**CULTURAL RESOURCES OFFICE
PRESERVATION BOARD
REGULAR MEETING
MONDAY –JANUARY 25, 2106 — 4:00 P.M.
1520 MARKET ST. #2000
ST. LOUIS, MO. 63103
www.stlouis-mo.gov/cultural-resources**

CITY OF ST. LOUIS
**PLANNING & URBAN
DESIGN AGENCY**
CULTURAL RESOURCES OFFICE
FRANCIS G. SLAY, Mayor

DATE: January 25, 2016
ADDRESS: 625 N. Euclid Avenue
ITEM: New Application to install one illuminated blade sign
JURISDICTION: Central West End Certified Local Historic District — Ward 18
STAFF: Andrea Gagen, Preservation Planner, Cultural Resources Office

PROPOSED SIGN LOCATION

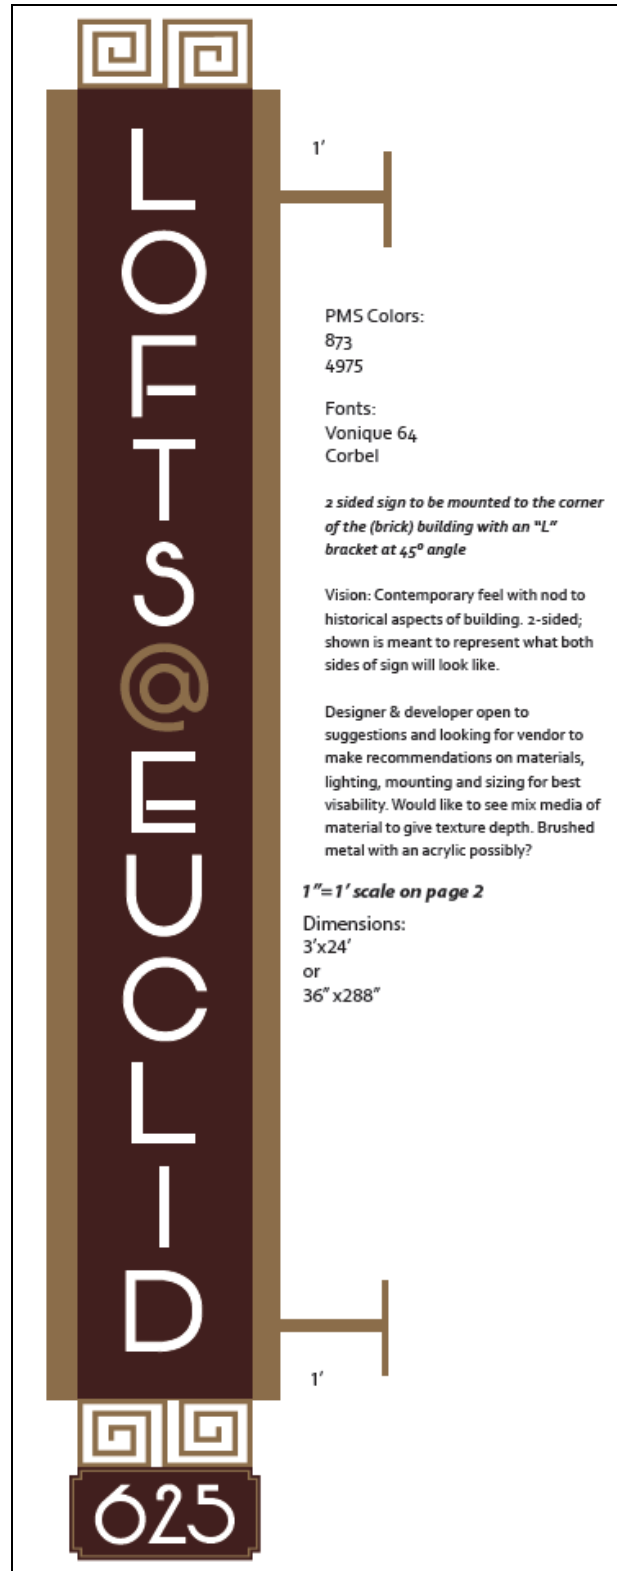
Does not comply. The proposed sign would be mounted above the second story window sill.

- 625 N. Euclid is located in the Central West End Local Historic District.
- The owner proposes to install a 3-foot by 24-foot internally illuminated projecting sign.
- The proposed sign would be mounted above the second story window sill, and the sign would not meet the Central West End Historic District standards.

- Yet the scale of the building and the sign are compatible and as the sign is identifying the entire building, and not a storefront business, its location above the second story window sill may be appropriate in this case.
- Historically, tall projecting signs like this were a feature of multi-story urban buildings.

Based on these preliminary findings, the Cultural Resources Office recommends that the Preservation Board approve the sign application, if it finds that the historic type of sign that identifies the entire building is appropriate in the proposed location.

EAST ELEVATION AND ADDITION ON EAST SIDE

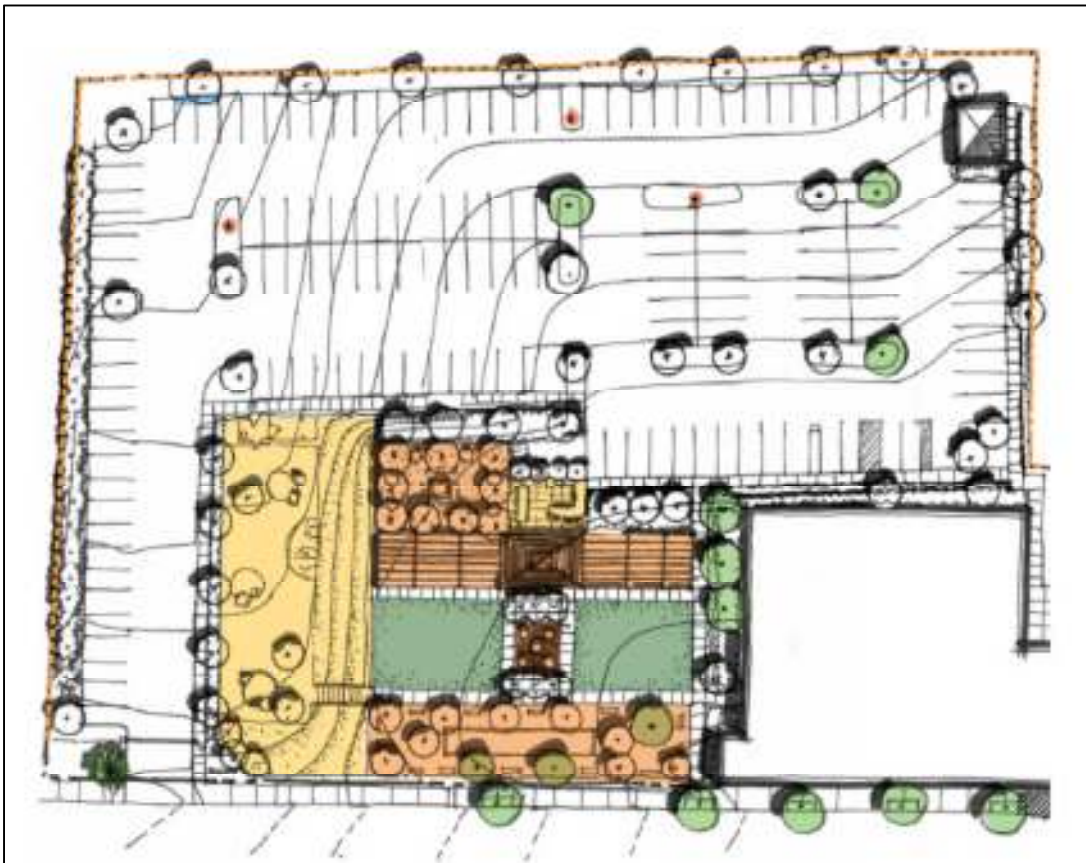
In terms of the ordinance, 2115 Hickory is Sound. Aerial photographs indicate that the roof is not in good repair and there is evidence of water moving through the brick walls.

The building consists of a ground story with a grid of closely-spaced columns supporting the floor above. The upper level is a tall, nearly double-height space with large windows filled with industrial steel sash. A steel truss system supports the roof and the three large clerestory roof lighting structures.

Due to topography, 2115-2131 Hickory is visible mainly from Hickory Street, as it faces a tall retaining wall on the south side of Hickory. Due to parking lots and grade changes, the building is visible from Chouteau. Its presence is compatible with the other shoe factory buildings immediate to the east and maintains the industrial character of most of this block of Hickory that changes only at the west end where four houses stand. The loss of this building would have a very noticeable impact on the integrity, rhythm, balance and density of the blockfront.

Based on these preliminary findings, the Cultural Resources Office recommends that the Preservation Board not grant Preliminary Approval to the demolition of 2115-2131 Hickory unless it finds that the denial of demolition would constitute an economic hardship.

PROPOSED 6105 DELMAR BOULEVARD BUILDING

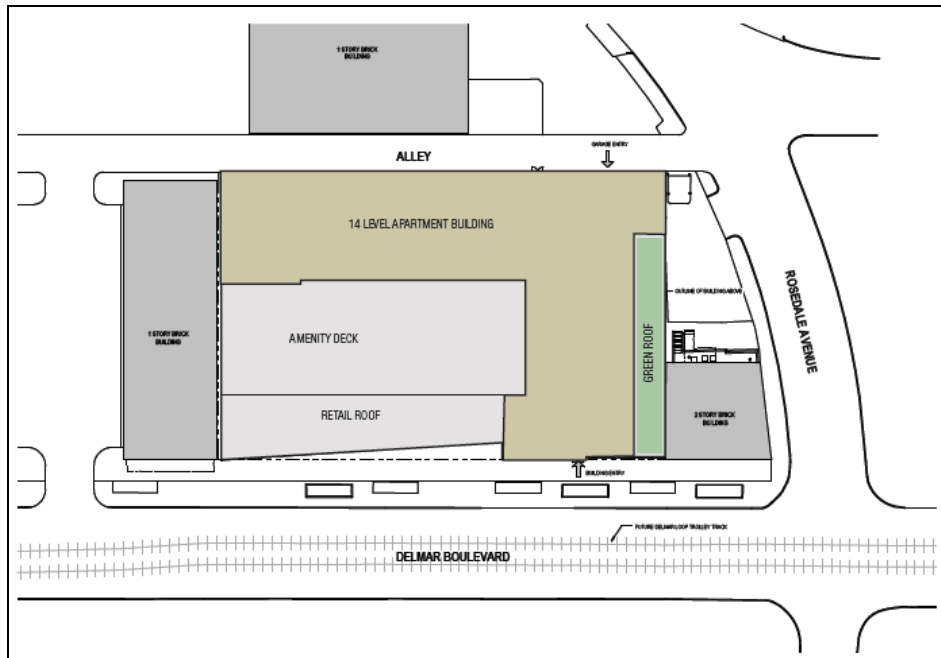
Does not comply. The 14-story building has the form of a podium with an L-shaped tower rising above it. The tower meets the street at the east end of the site and is set back at the rear of the podium at the north side. The podium fronts Delmar with a three-story form dominated by a two-story storefront. The building has been massed and designed to address the disparity in heights along Delmar. Its form and location of the tallest portion of the building, echoes that of the Moonrise Hotel, the tallest building on Delmar in the district at this time, which also has an L-form.

Mostly complies. The building would fill the entire Delmar frontage, as is the pattern for commercial buildings on Delmar. Part of it would meet the consistent building line on the north side of Delmar on this block. The podium has a shallow angle that widens the sidewalk at the east end of that component.

Complies. Brick, in two dominant red-brown shades, is proposed for the majority of the exterior of the building, including its side and rear elevations. As the building is a contemporary design, secondary materials include concrete board panels as cladding on the podium and upper stories. Cast stone is proposed to clad the east end of the podium. Brick at the storefront would be two accent colors. Metal Juliet balconies and a metal canopy at the storefront level would be accent materials. The lower portion of the third-story podium wall is proposed to be a “green wall,” covered with vegetation.

Mostly complies. The articulation of the building breaks it visually into vertical bays and other elements that are of comparable scale and rhythm to those on historic buildings. Individual window opening proportions are comparable. The larger glazed wall sections are more limited than the other pattern and compatible with the contemporary design.

Based on the Preliminary findings, the Cultural Resources Office recommends that the Preservation Board grant preliminary approval to the design if it finds the proposed height justified by the building's location within the district, and with the stipulation that final plans and exterior materials are reviewed and approved by the Cultural Resources Office.

4205 MARYLAND

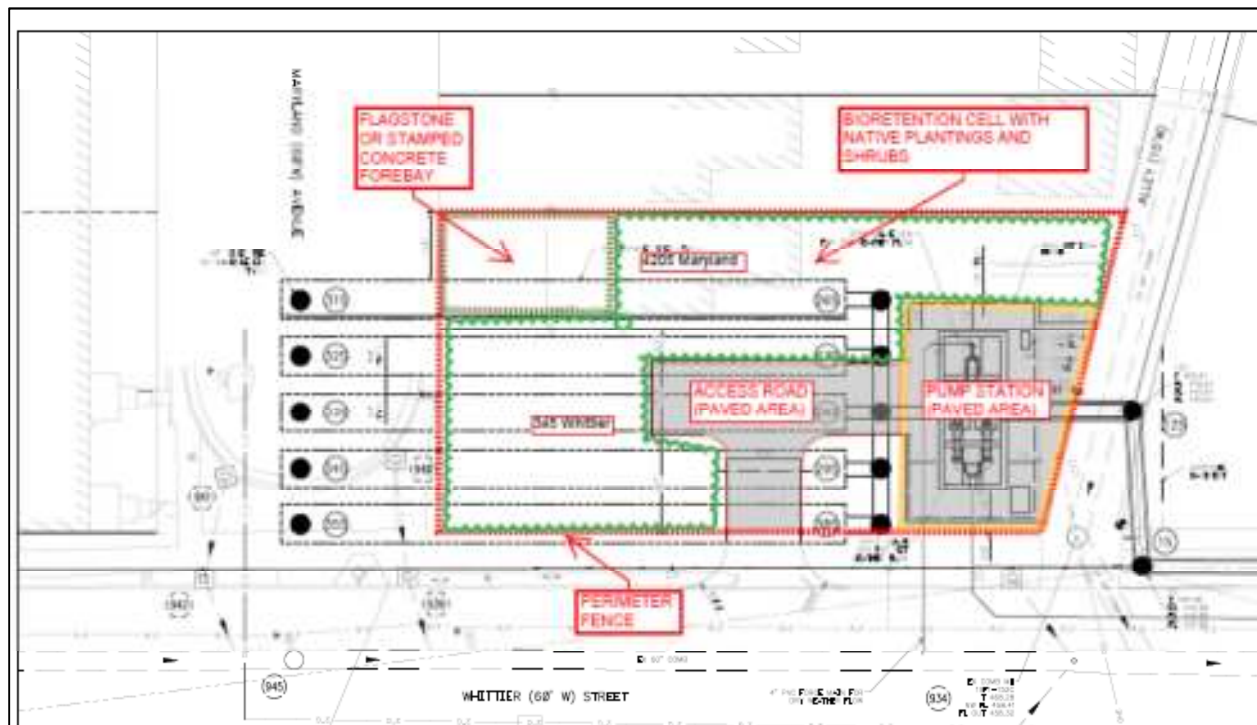
The effect of the loss of the two Merit buildings on the urban fabric would be a relatively small change on the west side of Whittier, in terms of the much more dominant modern shopping center and Schnucks store on the east side of Whittier. While Whittier is the logical boundary for the district, the properties on that street are varied and include new construction at Lindell and McPherson. On Maryland, 4205 is the easternmost house on the north side of the street.

Based on these preliminary findings, the Cultural Resources Office recommends that the Preservation Board grant Preliminary Approval to the demolition of the two Merit buildings as the Metropolitan St. Louis Sewer District has carefully sited the project for maximum efficiency and to solve serious sewer problems; as the site is in a portion of the Central West End Local Historic District that has a varied character; and as the project would not introduce the loss of historic buildings into a strong historic streetscape nor cause the loss of buildings with special architectural quality. The Cultural Resources Office also recommends that the final design of the landscaping for the site be reviewed and approved by the Office.

GOOGLE PHOTO OF WALL BEFORE DEMOLITION

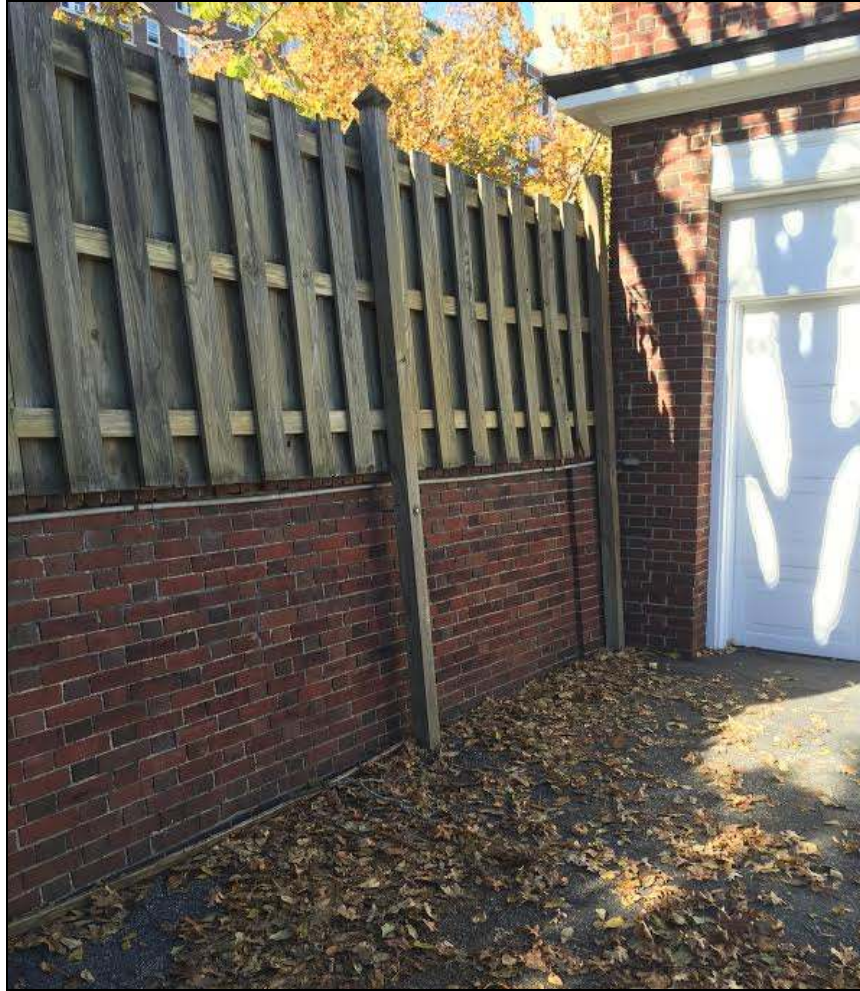
In late November, the applicant applied for a permit to remove and install a wood fence at 54 Westmoreland Place. During construction, the Cultural Resources Office received a complaint that an historic brick wall at the property was being demolished. The office issued a Stop Work Order for the project, but the wall had been removed at that point. The applicant has now applied for a permit for the demolition that occurred without a permit. The permit was not approved as the demolition does not meet the Central West Historic District standards.

Based on these preliminary findings, the Cultural Resources Office recommends that the Preservation Board uphold the Director's denial of the application for the demolition of the wall, as it does not comply with the Central West End Local Historic District standards, and require that the historic wall be replicated.

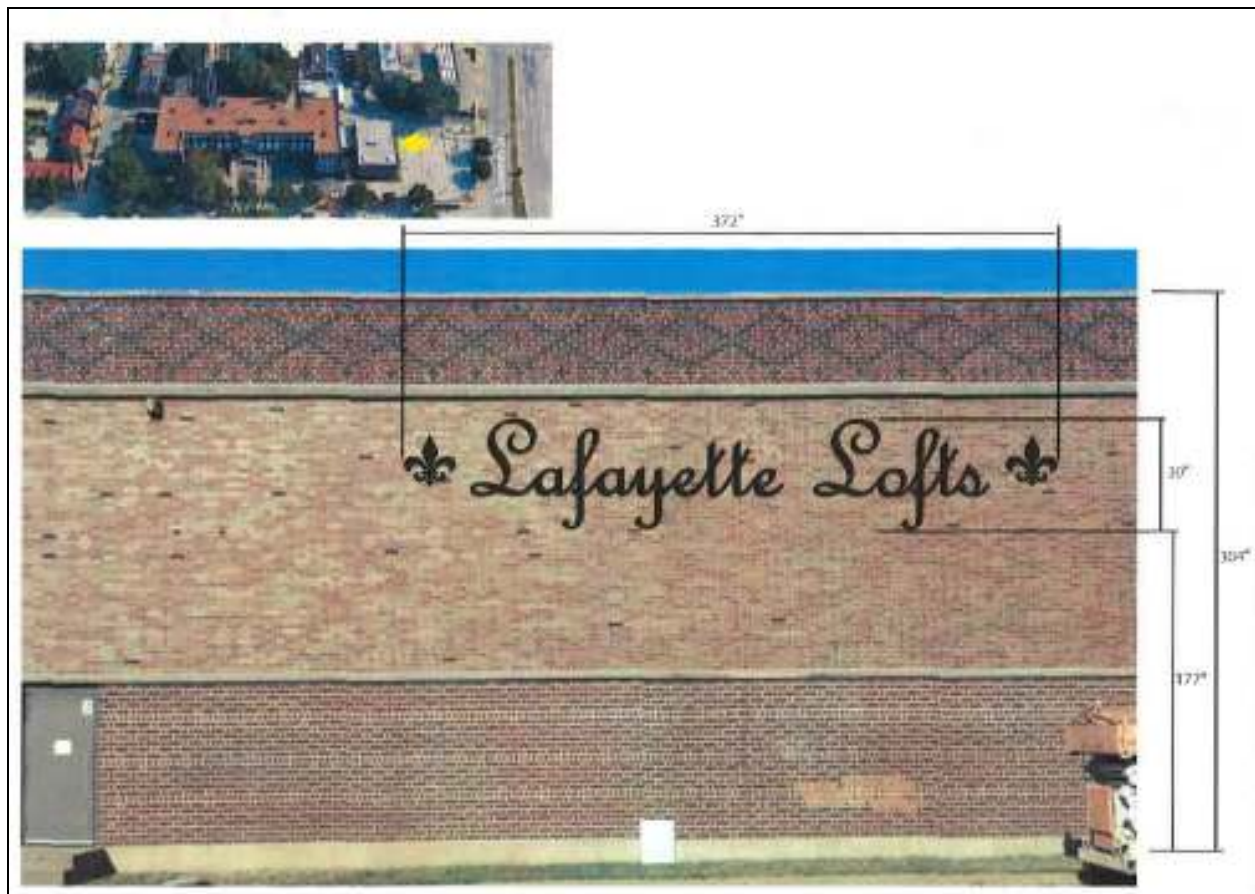
Partially complies. The sign proposed for the Ann Avenue side of the building conforms to historic district standards. The sign proposed for the 7th Street side of the building does not comply as it is almost double the square footage allowed under the standards.

- 815 Ann Avenue is located in the Soulard Local Historic District.
- The owner proposes to install two non-illuminated wall signs on the building.
- The proposed sign on the Ann Avenue façade conforms to the Soulard Historic District standards.
- The sign proposed for the 7th Street façade, which would be placed on the wall of the gymnasium, is 2.5 feet by 31 feet, a total of 77.5 square feet. This is nearly twice the maximum area allowed under the historic district standards.
- As the sign identifies the entire building, and is proposed on a large wall with no openings, there may be some justification to the 40 square foot maximum size, but perhaps not as much as is being requested.
